Intersection ID: 44684	Main Street: CEDAR_CROFT_DR	Cross Street: LARRISA_CT	Location:	NE
ADA ID: 3B024750FCF2	Ramp Type: PerpDiag	Initial Pass/Fail: Fail	Overall Compliance: No	Severity Score: 58.75

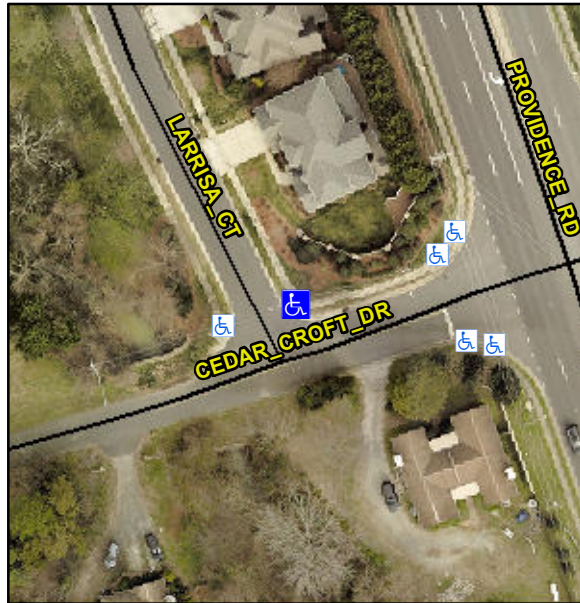
**Not Found, R304.5.1, R304.2.2,
R304.5.3**

Compliance	Description	Data	Compliance	Description	Data
N/A	Ramp Length (in)	48.0	No	Ramp Slope (%)	13.2
No	Ramp Width (in)	44.0	No	Ramp XSlope (%)	13.0
N/A	Flare Type LT	N/A	N/A	Flare Type RT	N/A
N/A	Flare Slope LT (%)	N/A	N/A	Flare Slope RT (%)	N/A
N/A	Flare Traversable LT?	N/A	N/A	Flare Traversable RT?	N/A
N/A	Landing Length (in)	N/A	N/A	DWS Provided?	N/A
N/A	Landing Width (in)	N/A	N/A	DWS Contrast?	N/A
N/A	Landing Slope (%)	N/A	N/A	DWS Length (in)	N/A
N/A	Landing X Slope (%)	N/A	N/A	DWS Full Width?	N/A
N/A	Landing Curb? (Y/N)	N/A	N/A	DWS Offset (in)	N/A
N/A	Shared Landing?	N/A			
N/A	Gutter Ponding?	N/A	N/A	Gutter Slope (%)	N/A
N/A	Gutter Lip Ht (in)	N/A	N/A	Gutter X Slope (%)	N/A
N/A	Painted X Walk1?	No	N/A	Painted X Walk2?	No
	X Walk 1 Direction	To W		X Walk 2 Direction	To S
N/A	X Walk 1 Width (in)	N/A	N/A	X Walk 2 Width (in)	N/A
	X Walk 1 Slope (%)	4.4		X Walk 2 Slope (%)	2.3
	X Walk 1 X Slope (%)	5.8		X Walk 2 X Slope (%)	9.2

Remove & Replace Curb Ramp With Two New Directional Ramps or Equivalent.
